A D D E N D U M #2

Project	Nelson H.S. Renovations	**Project No.**	2323
Location	4181 New Street, Burlington, Ontario	**Date of Issue**	2024 05 30
Owner	The Halton District School Board	**File**	2323/7.1.3

This Addendum forms part of the Contract Documents and amends the original Drawings and Specifications, dated 2024 05 13, as noted below.

1 E302 SECOND FLOOR (EAST WING) MODIFICATION LAYOUT (PART 1/2)
1:100

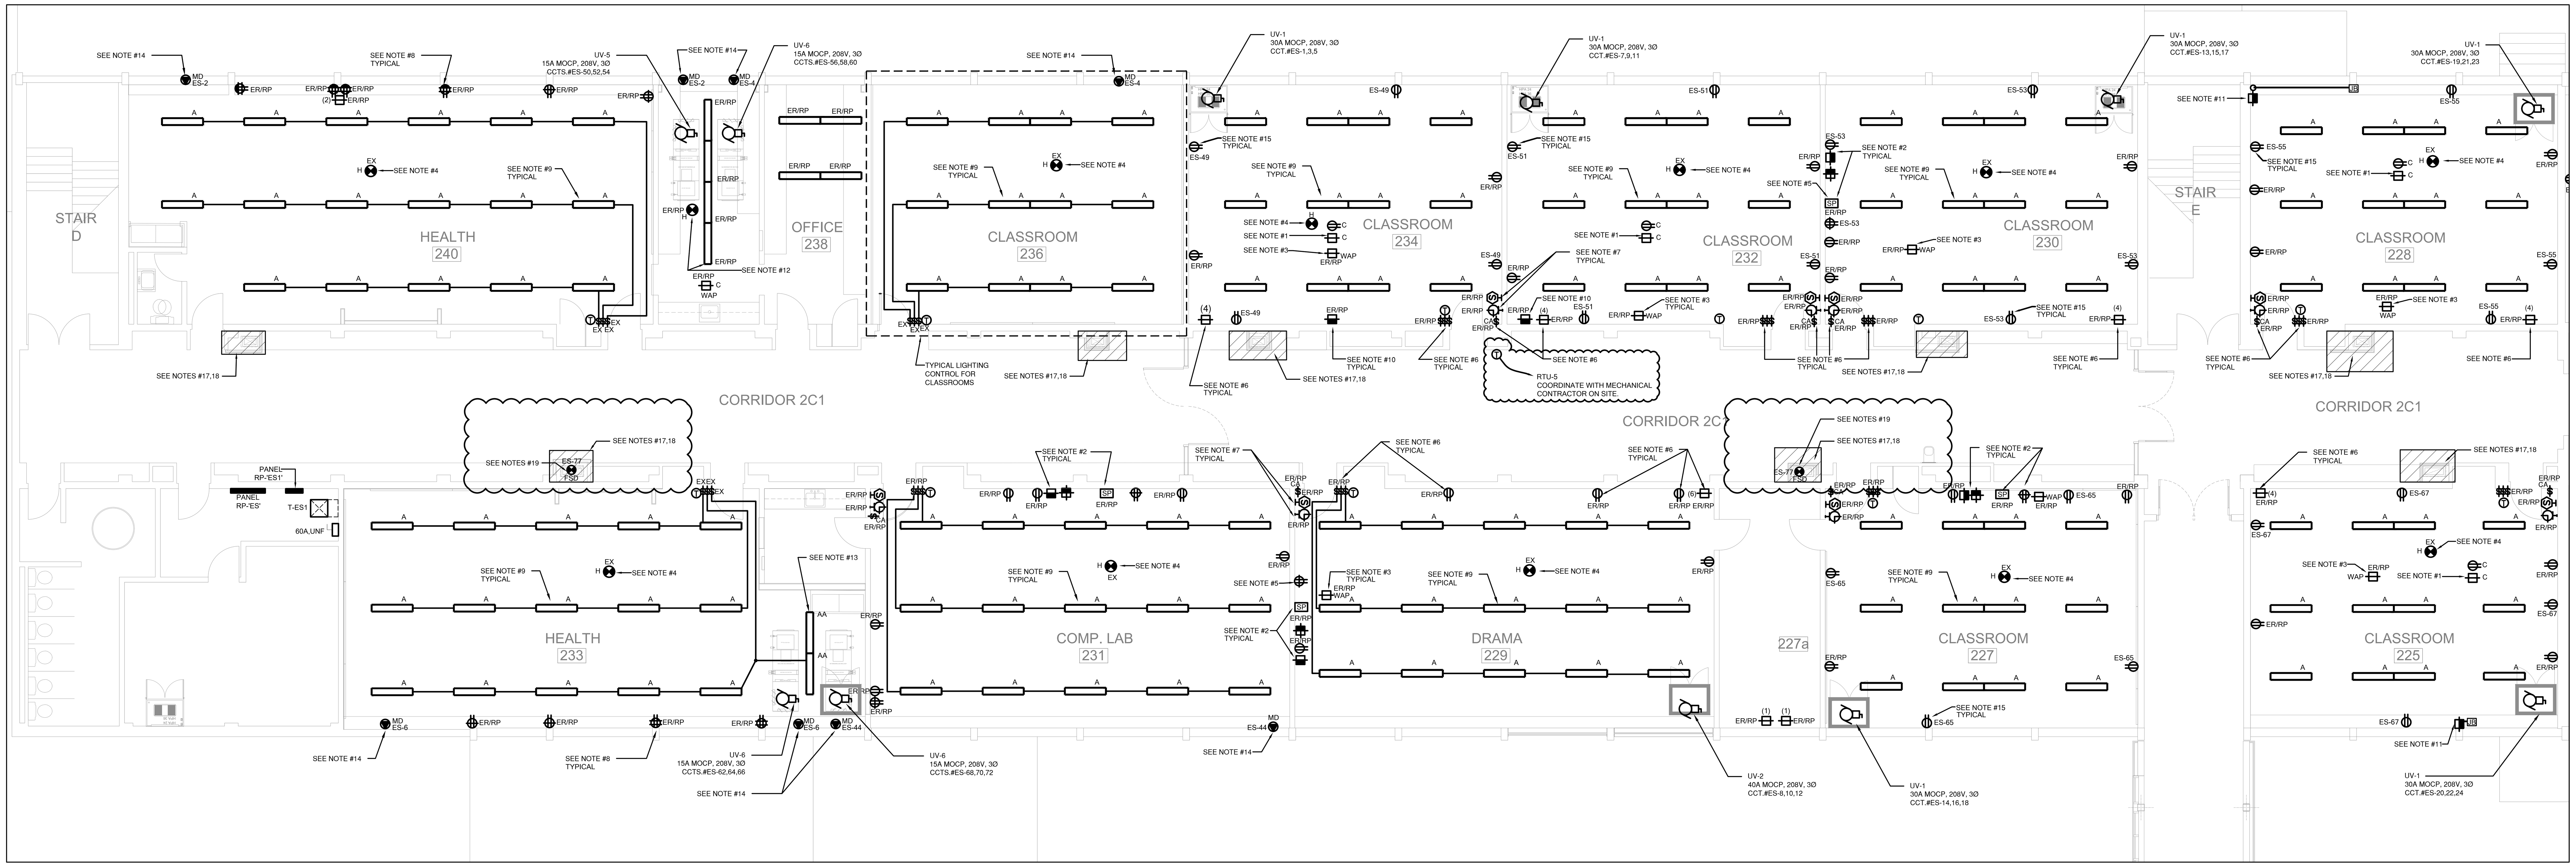
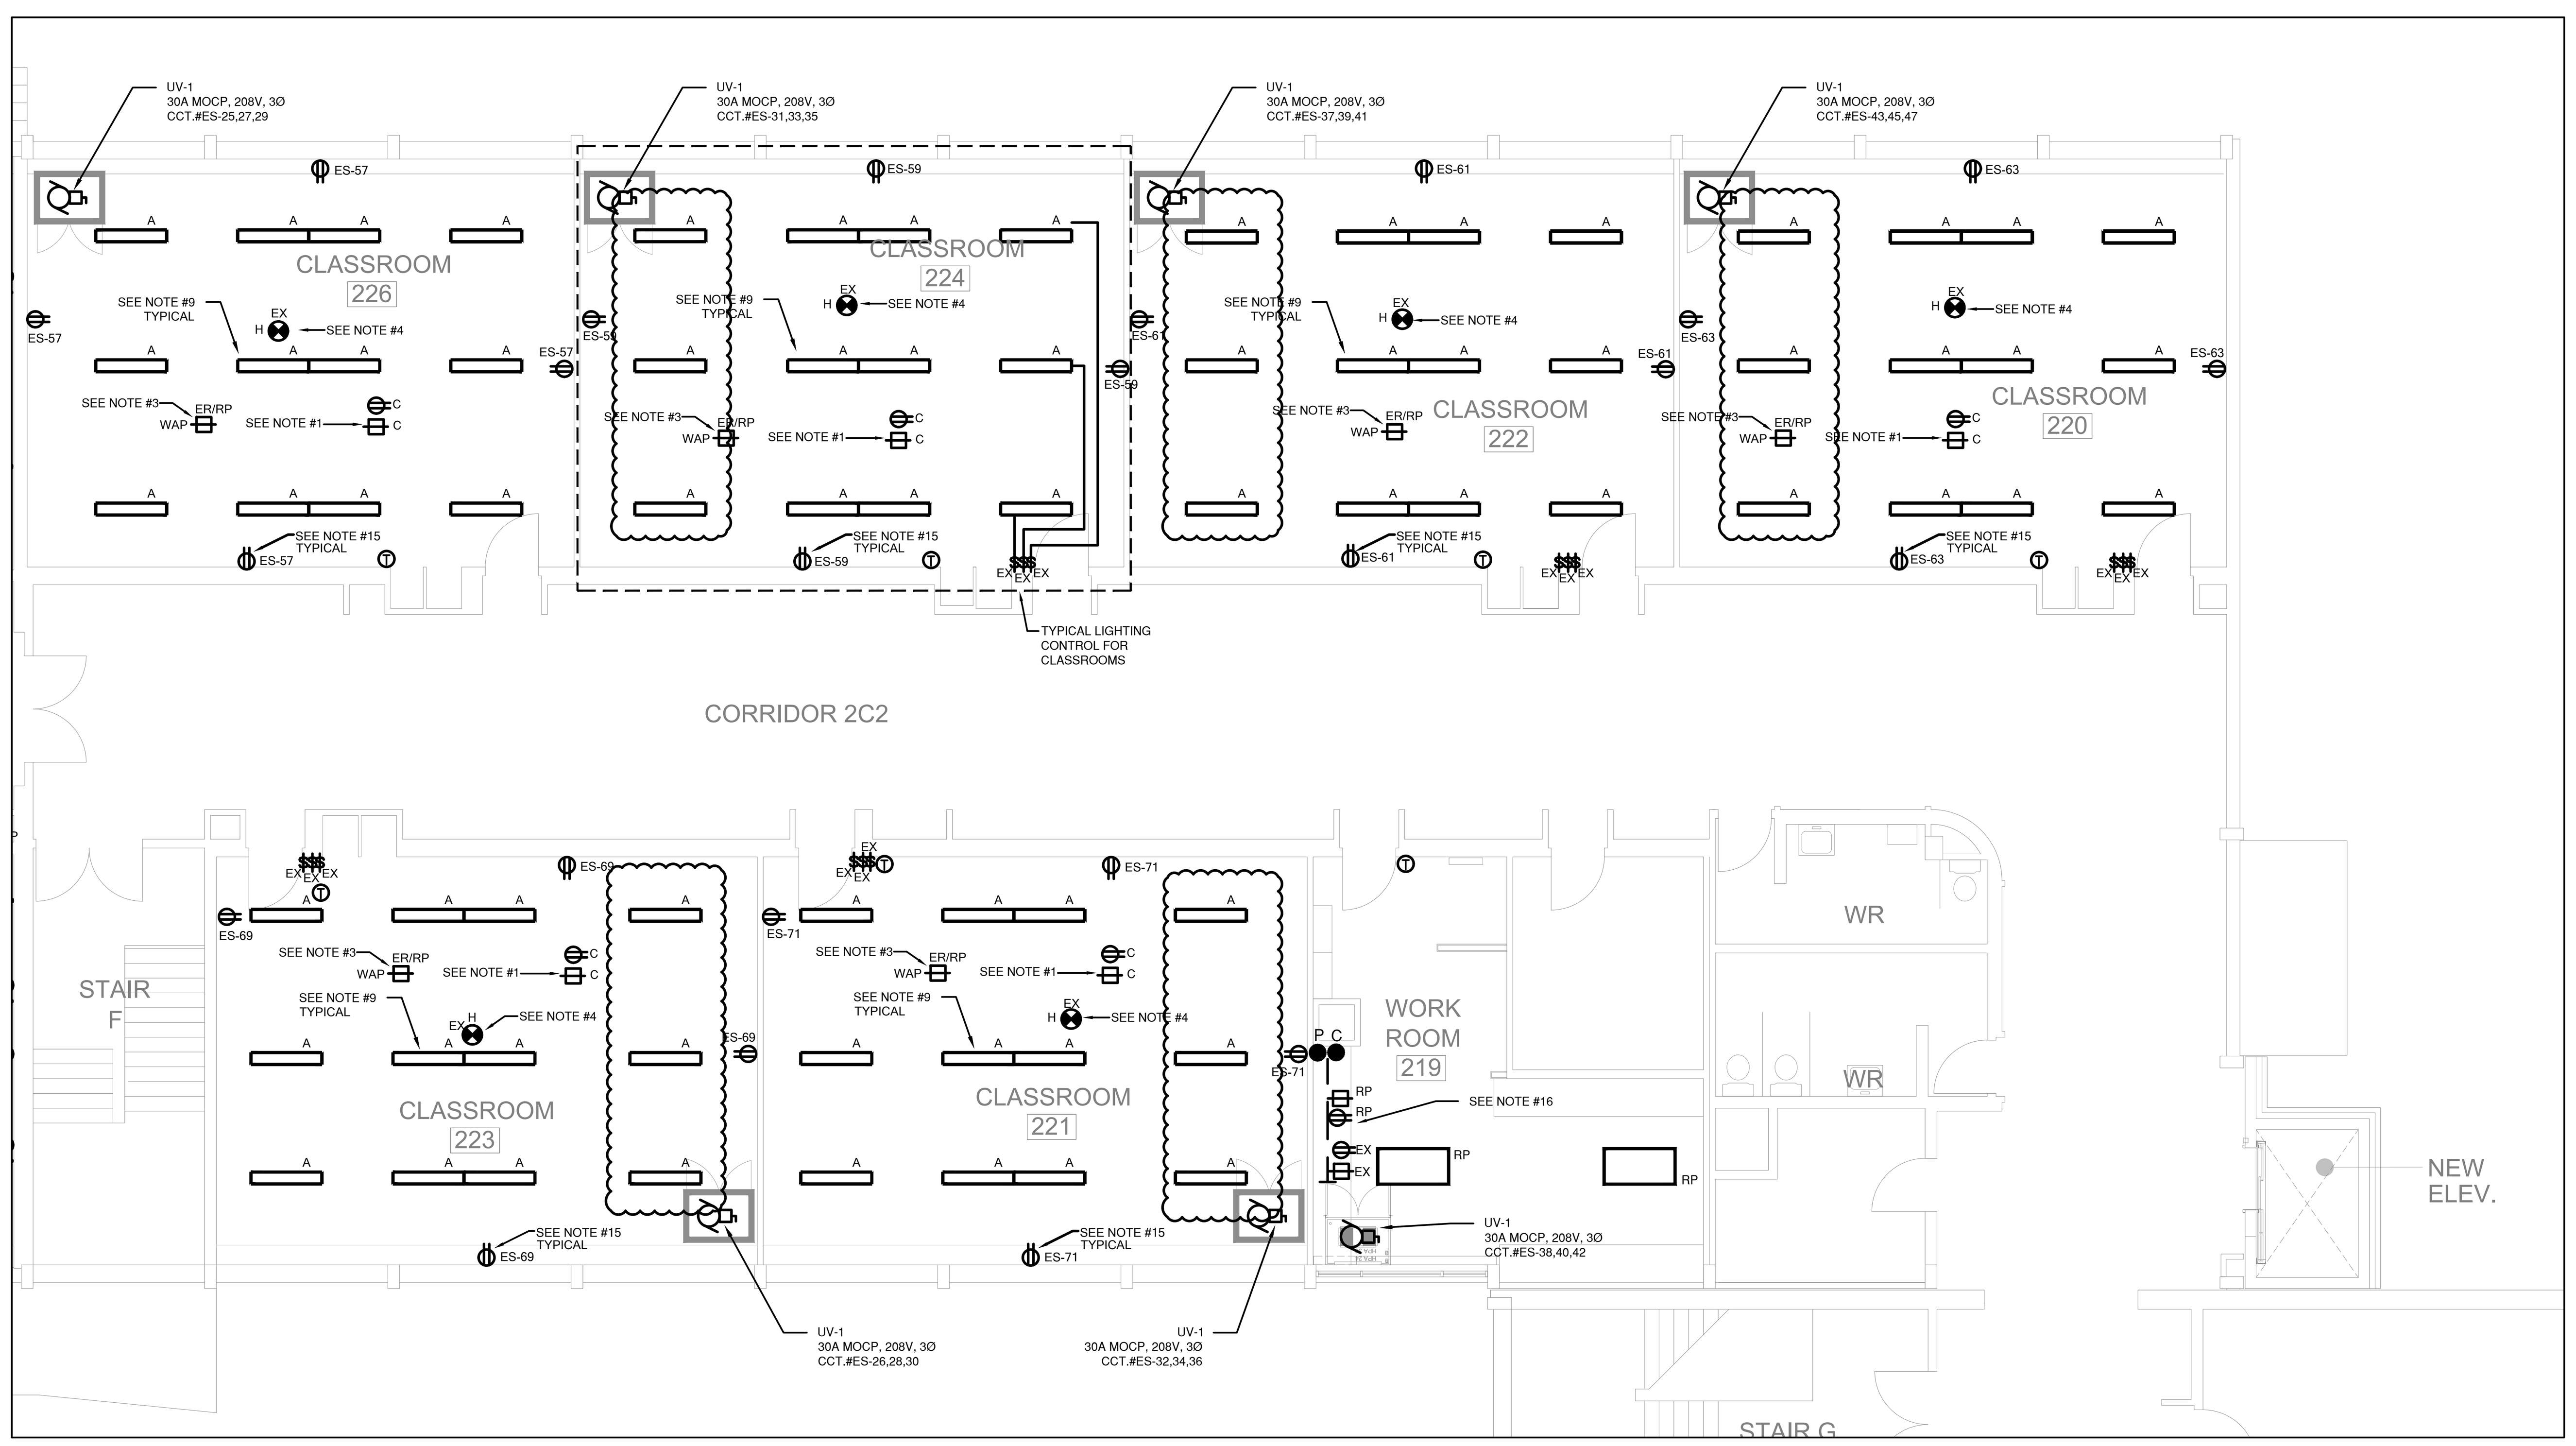
.1 Refer to Drawing E302 and include the changes indicated.
- Relocated light fixtures in classrooms to suit UV cabinets.
- Added power connection for fire smoke damper and associated duct smoke detector to be interlocked with fire smoke damper and note #19.

1 E303 **SECOND FLOOR (SOUTH WING) MODIFICATION LAYOUT (PART 1/2)**
1:100

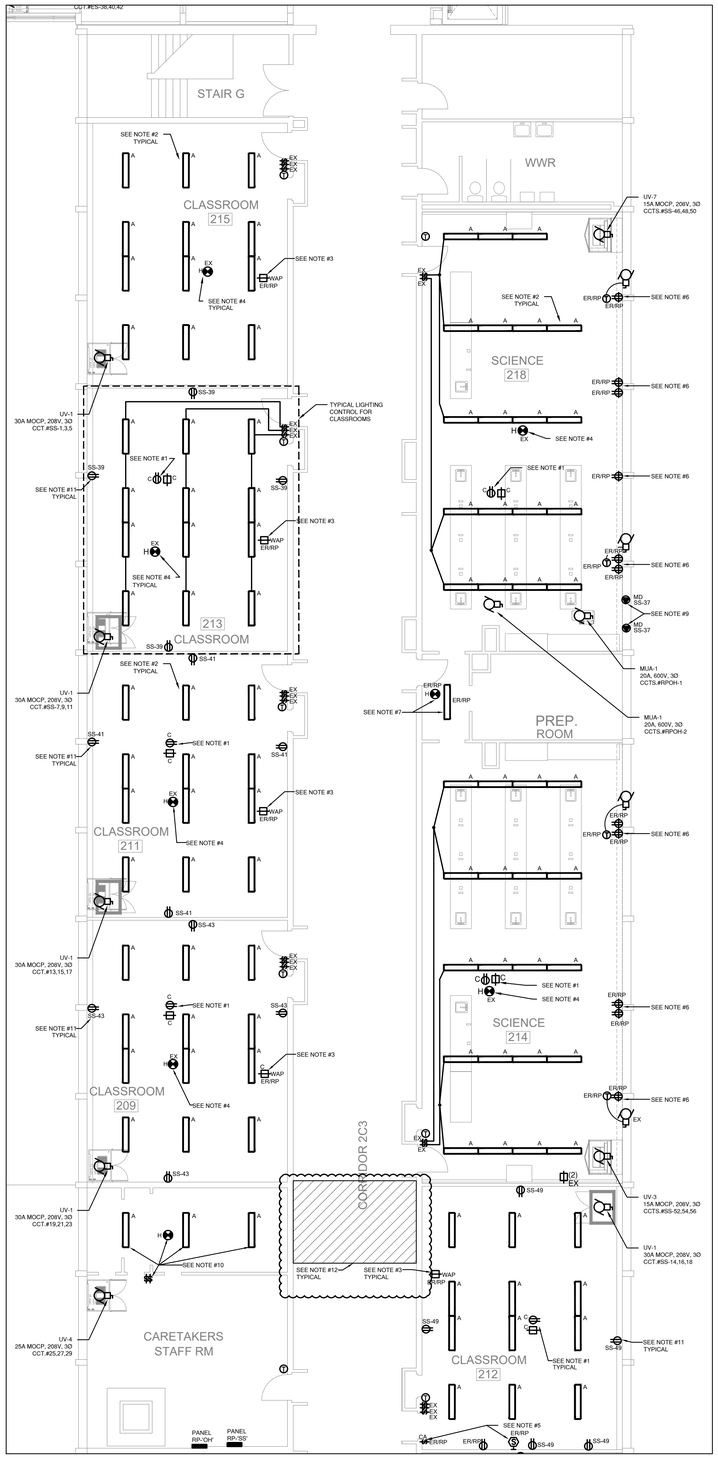
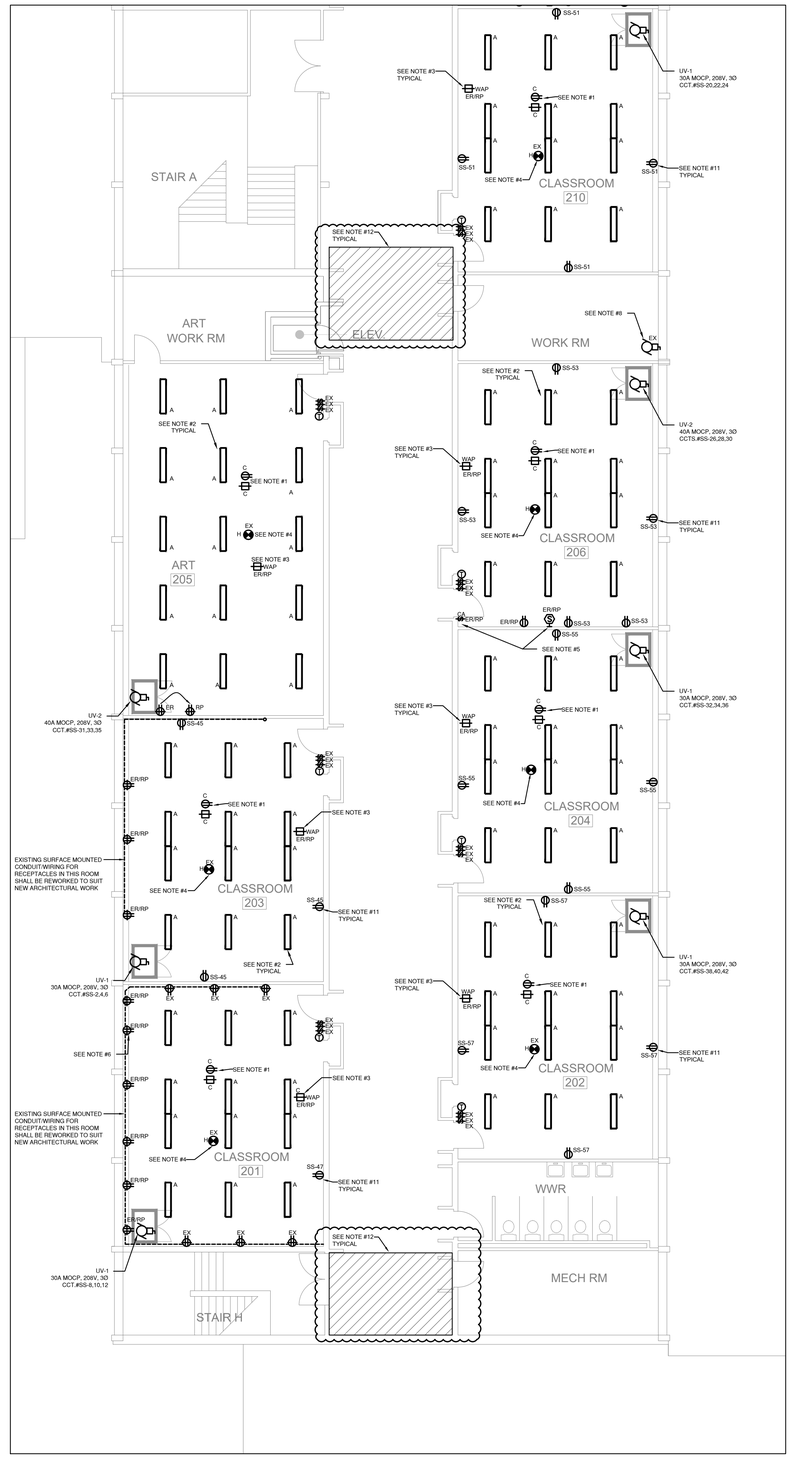
.1 Refer to Drawing E303 and include the changes indicated. Added note #12 and identified area of work in the corridor.

1 E400 **ROOF FLOOR DEMOLITION AND MODIFICATION LAYOUT**
1:300

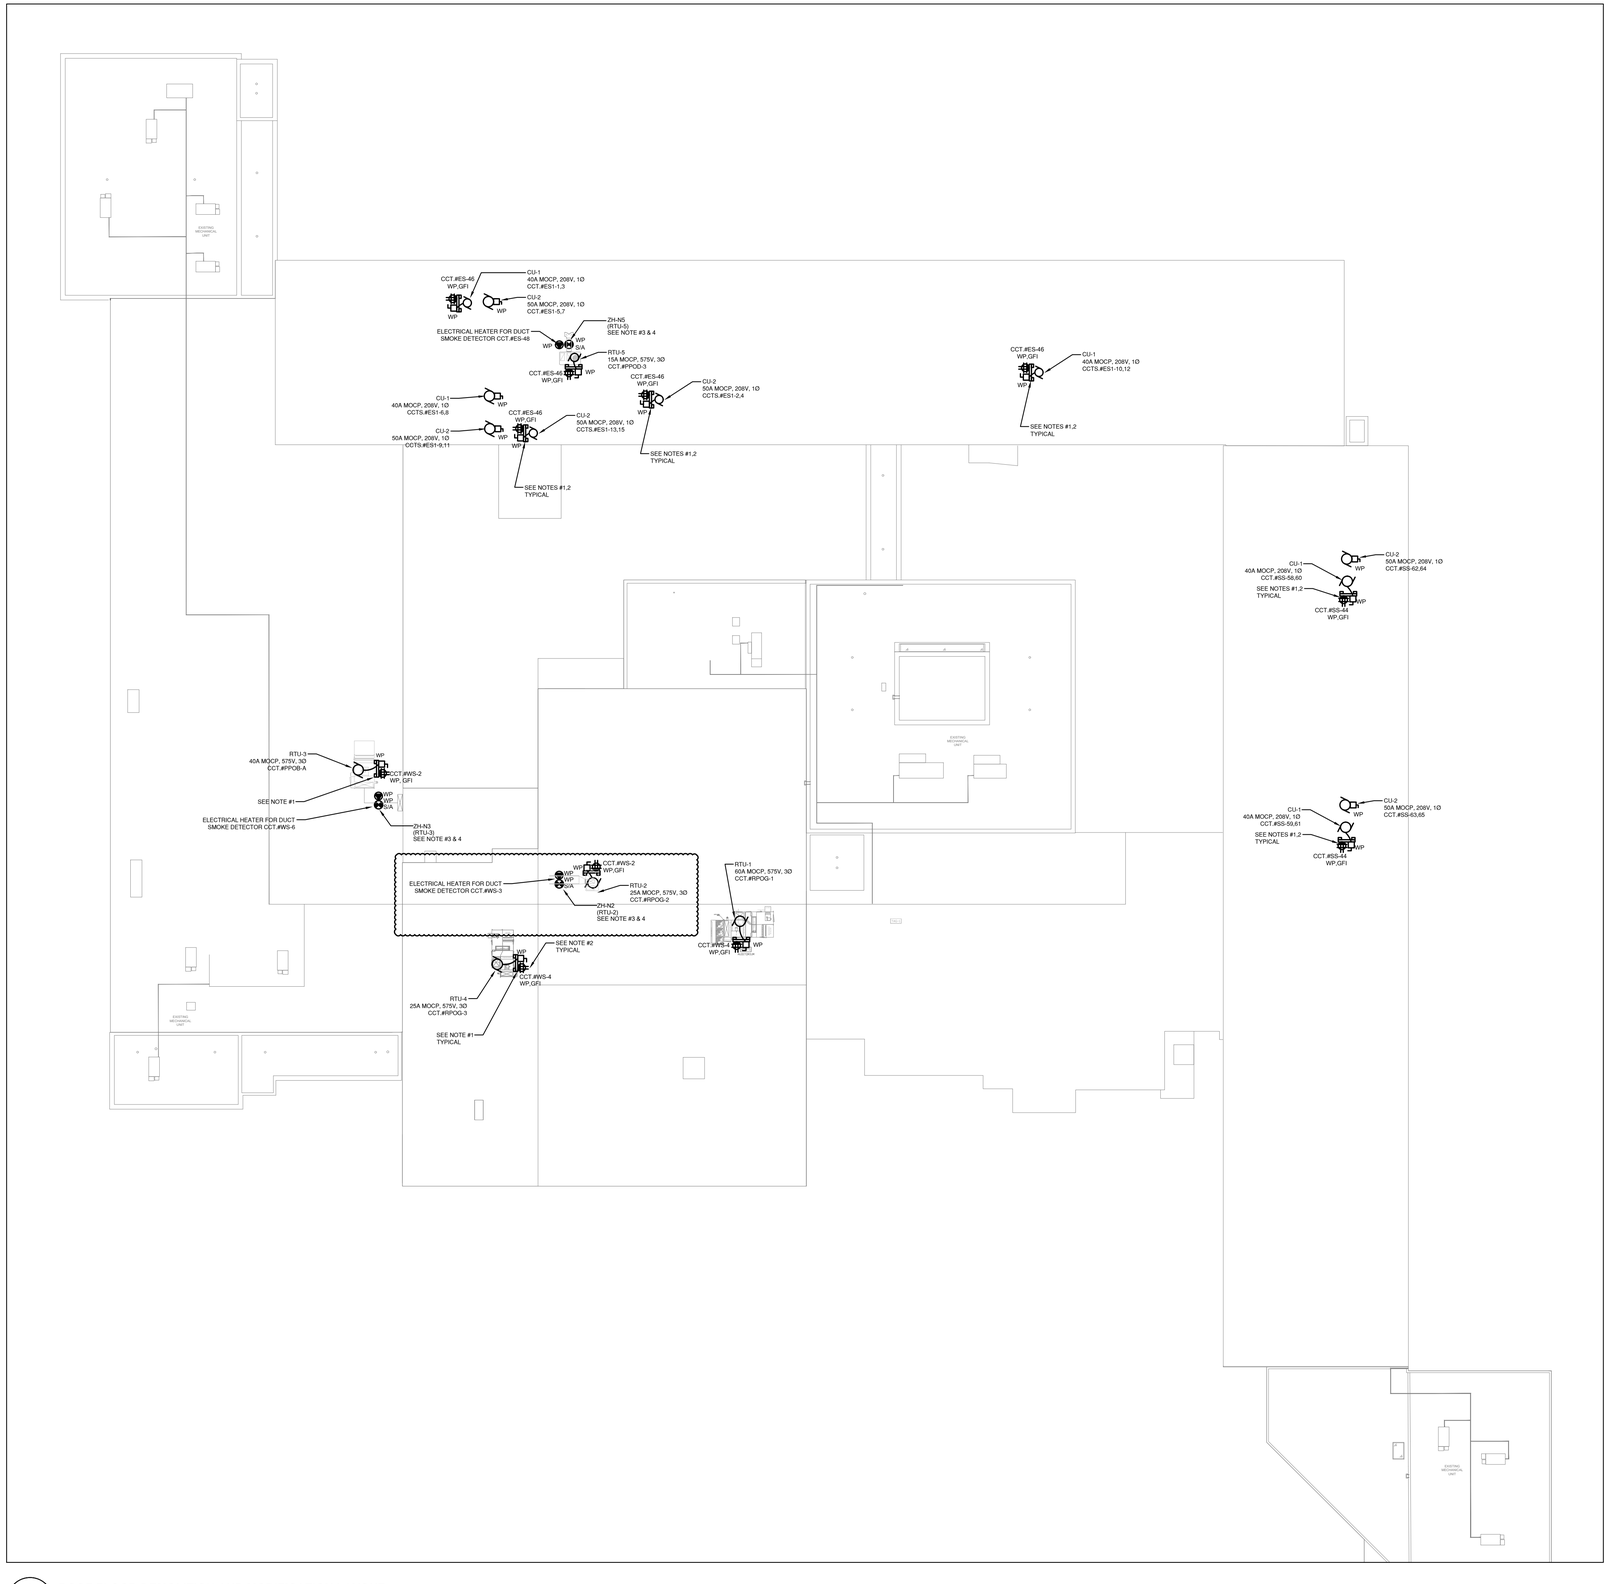
.1 Refer to Drawing E400 and include the changes indicated. Added duct smoke detector and heater for RTU-2 on the roof.

NEW PANEL PP-'OD'

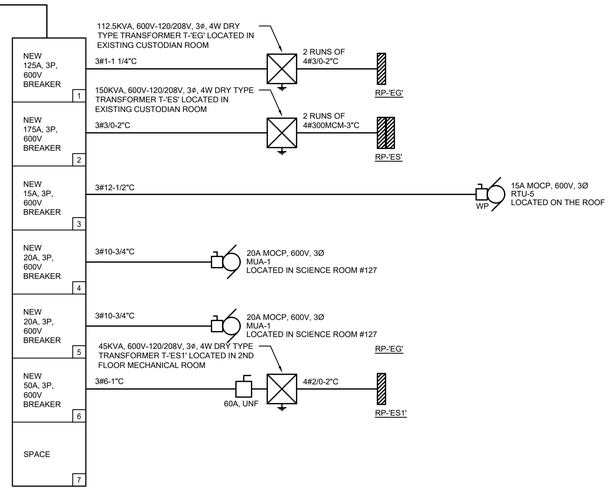
.1 Refer to Drawing E400 and include the changes indicated. Added Panel elevation for panel PP-OD.
